CITY OF NEWTON

PUBLIC FACILITIES COMMITTEE AGENDA

SUBJECT: 100% Schematic Design and Site Plan Review

Re: Administrative Site Plan Review – Newton Fire Station #10 Oak Hill

Newton Fire Station 10 - Oak Hill
 Newton, MA 02459
 project number: 1106.00
EXISTING CONDITIONS PLAN

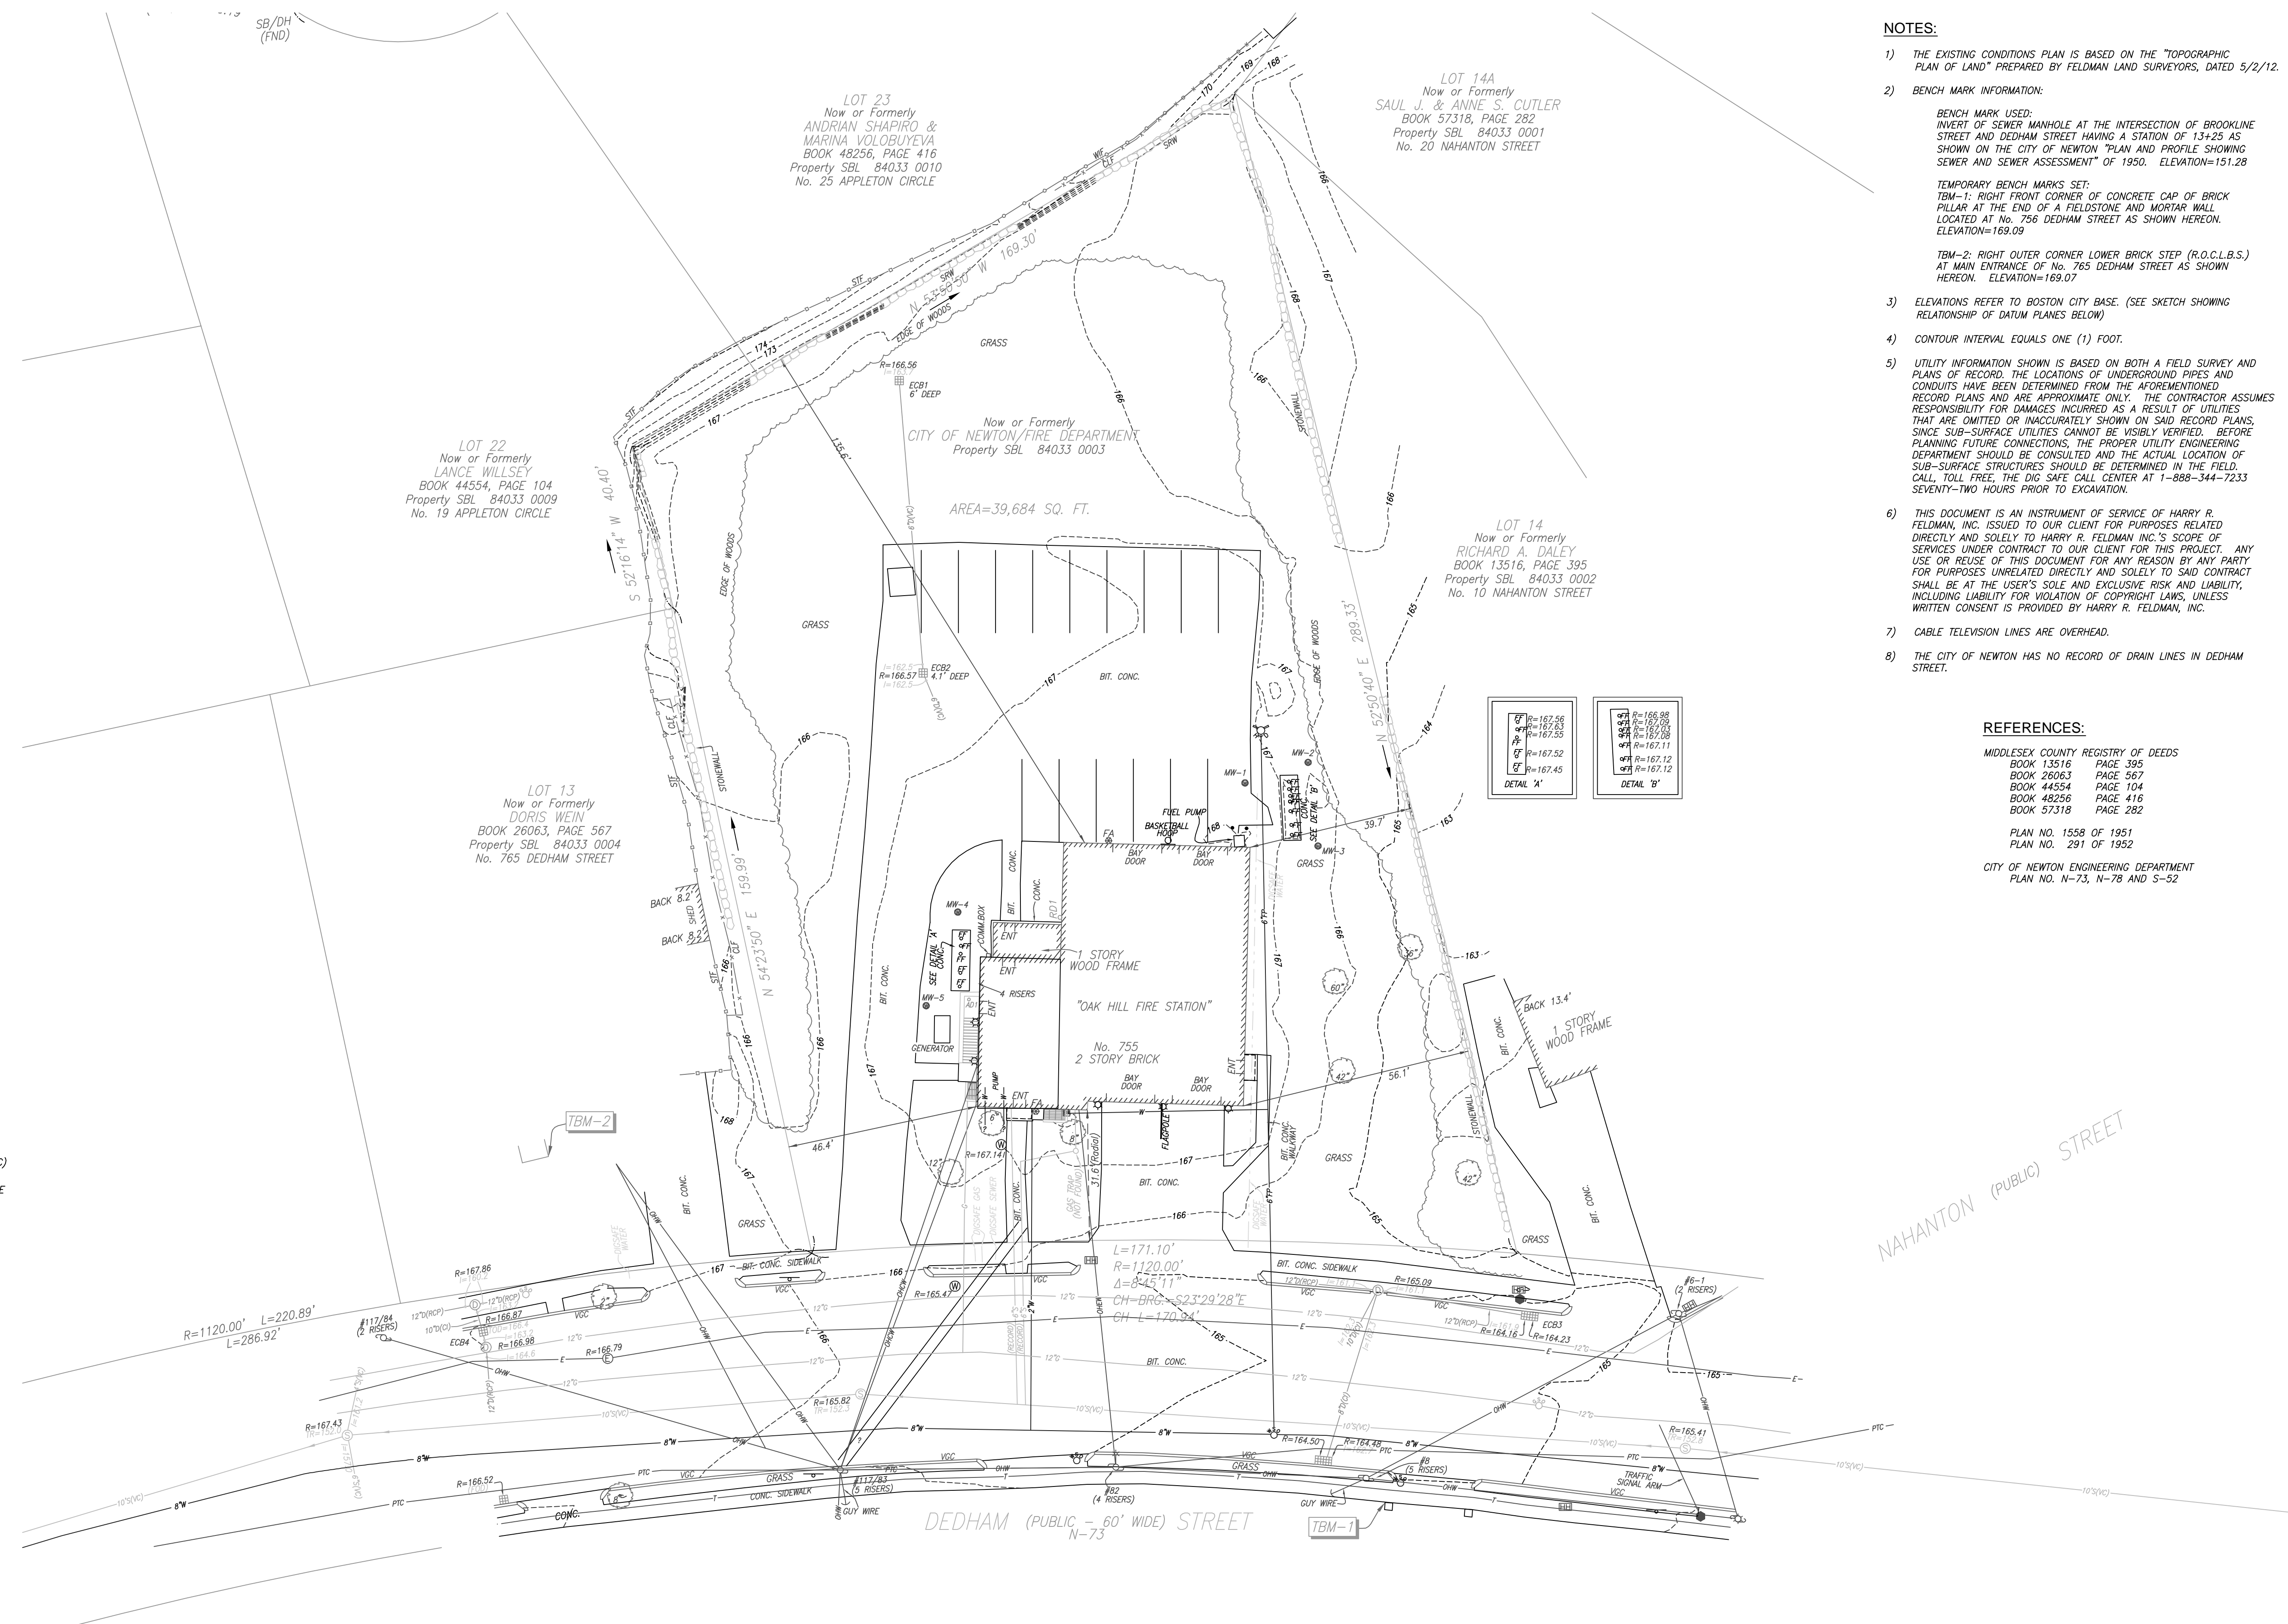
- In addition, current plans do not address the removal or relocation of an onsite gas pump and underground gas tank, nor do they show dimensional information or elevations for the proposed Confinement Enclosure or Drafting Tank.

Newton Fire Station 10 - Oak Hill
 Newton, MA 02459
 project number: 1106.00
PROPOSED UTILITIES PLAN

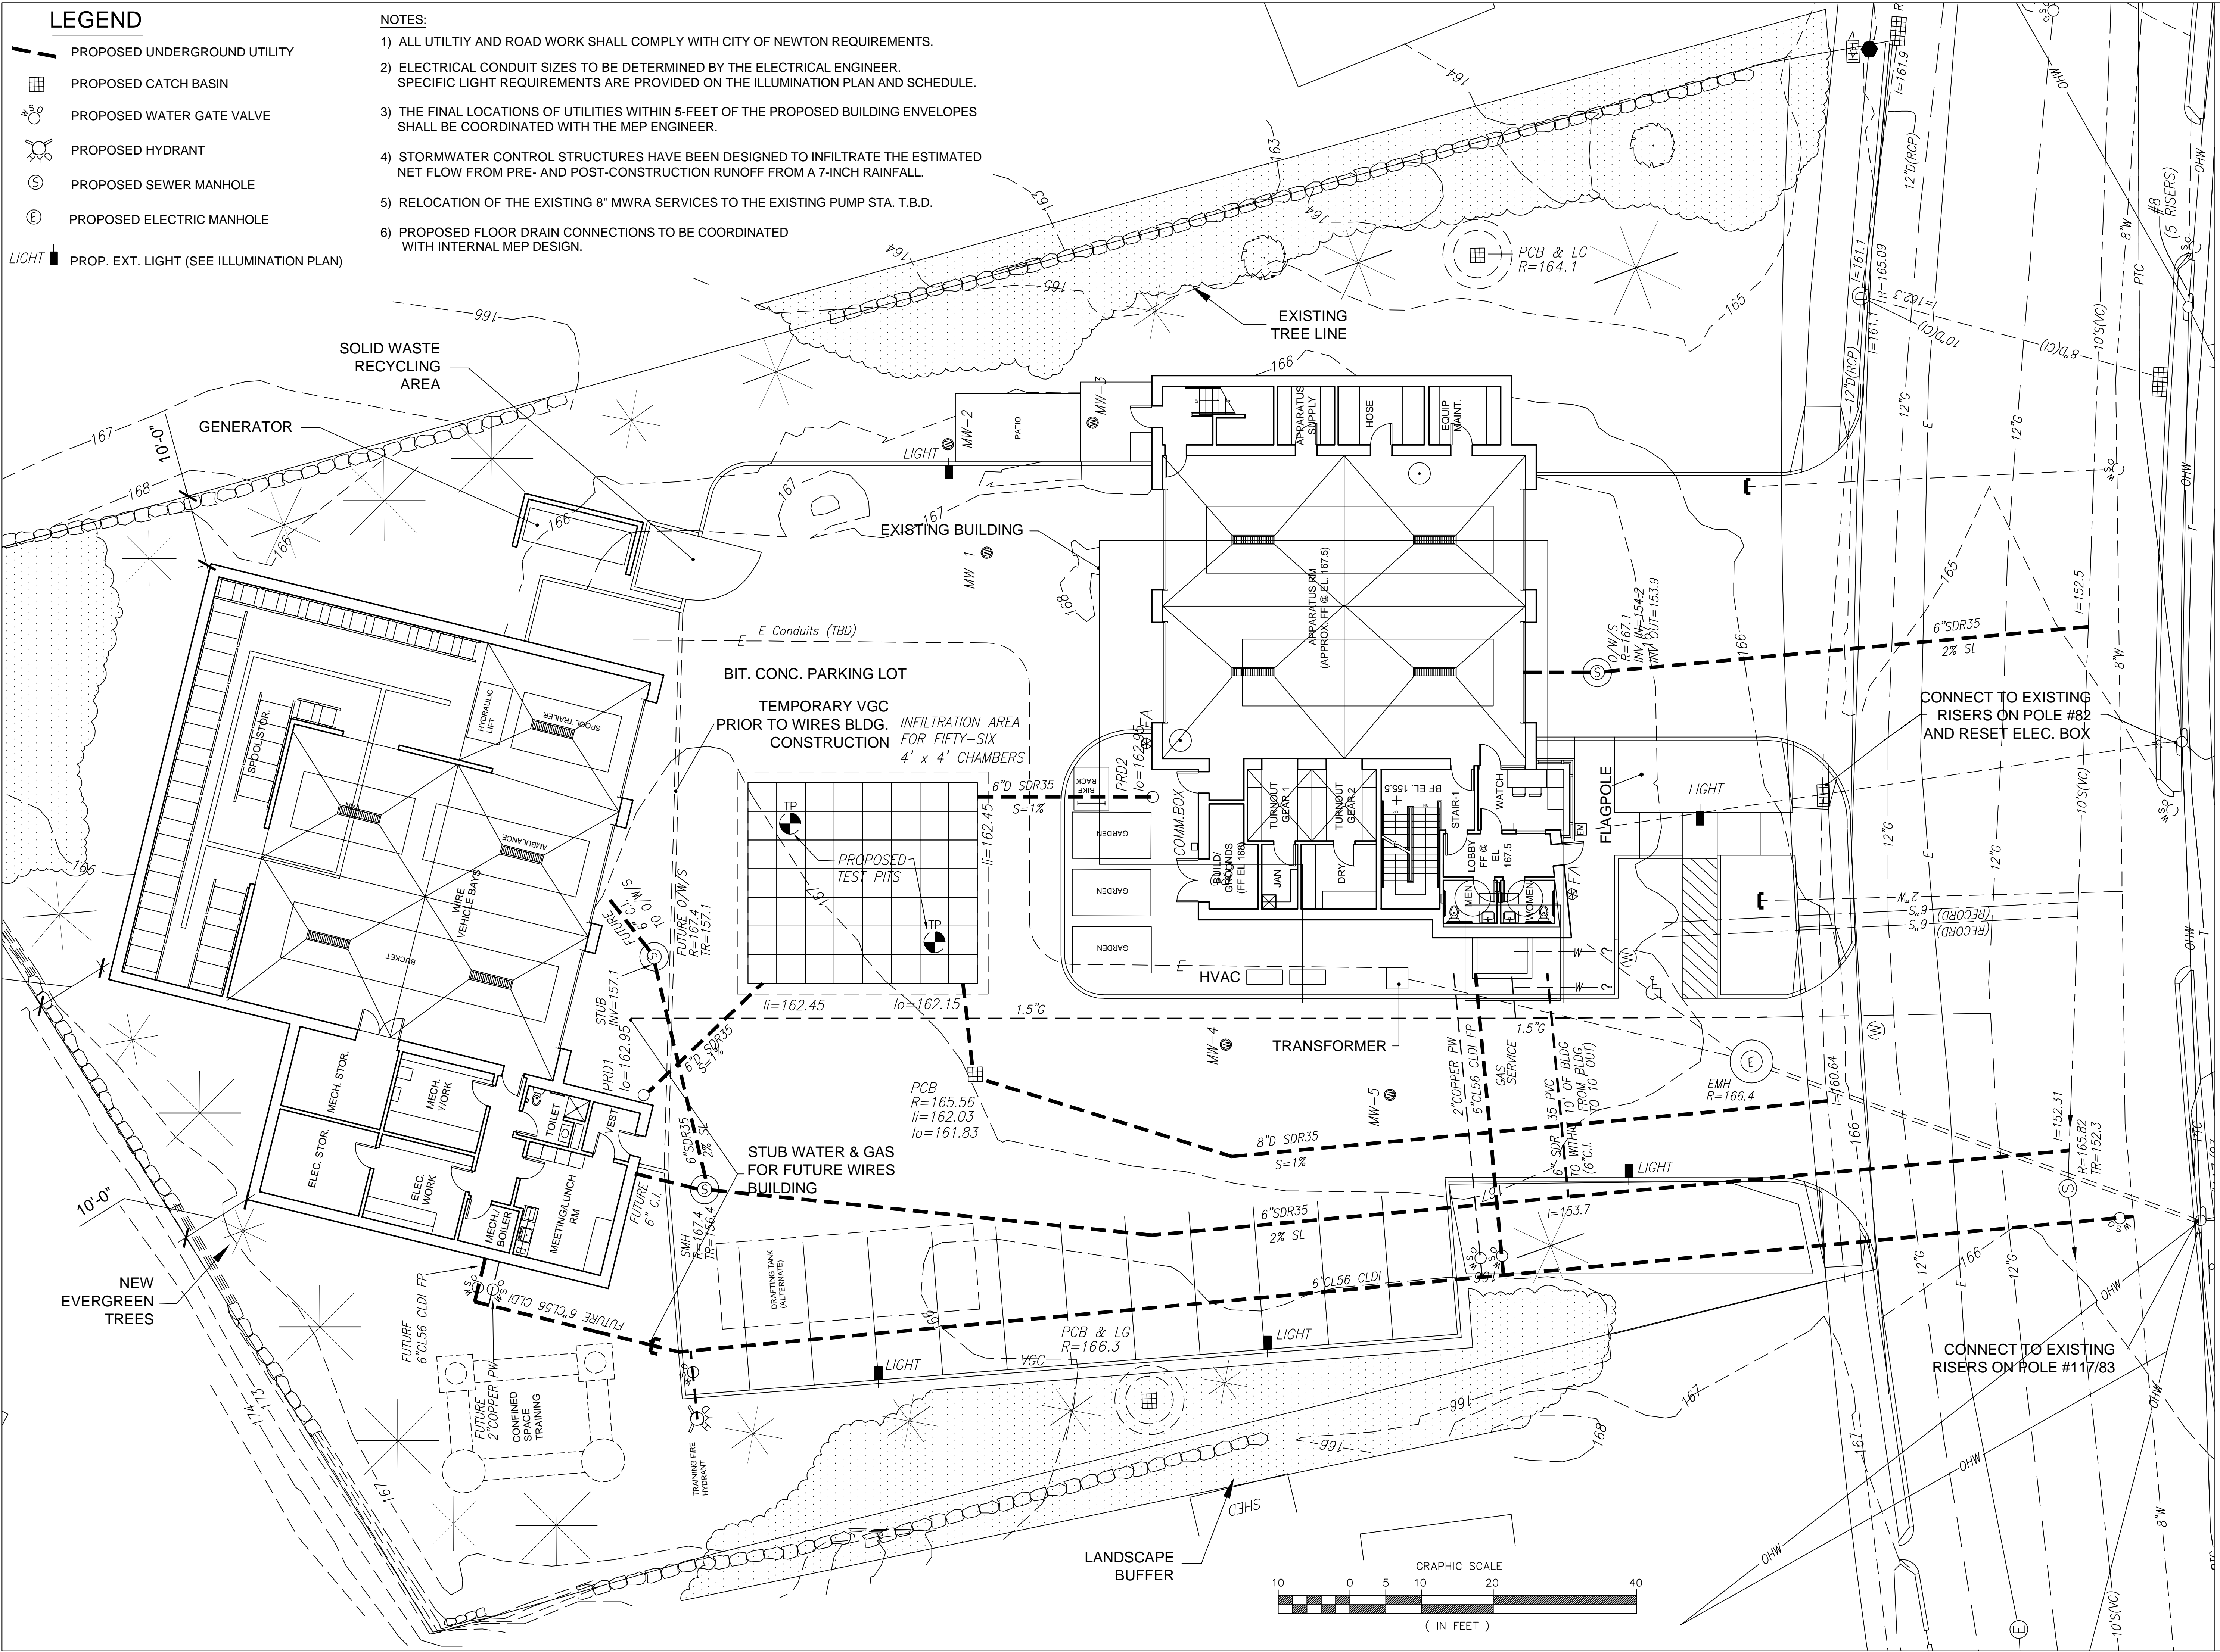
1. A detail for a forced main is shown, yet nothing on the site plan, what is this for?
2. The 4" HDPE is not acceptable as a service connection to the new building, it shall be 6" SDR 35 PVC to within 10' of the foundation at which time it must be 4" cast iron pipe per Massachusetts Plumbing Code.

7. The existing sewer manhole table will have to be modified.
8. The slope for the proposed sewer services needs to be indicated.

9. The existing water & sewer services shall be cut and capped at the main and be completely removed from the site and properly back filled. The Engineering Division must inspect this work; failure to having this work inspected my result in the delay of issuance of the Utility Connection Permit. ***This note must be incorporated onto the site plan.***

10. A detailed profile is needed which shows the existing water main, proposed water service, sewer main and proposed sewer service with the slopes and inverts labeled to ensure that there are no conflicts between the sewer services and the water service. The minimum slope for a service is 2.0%, with a maximum of 10%. In order to verify the slopes and inverts of the proposed service connection, two manholes of the existing sanitary sewer system need to be identified on the plan with rim & invert elevations. The crown of the service connection & the sewer man need to match.
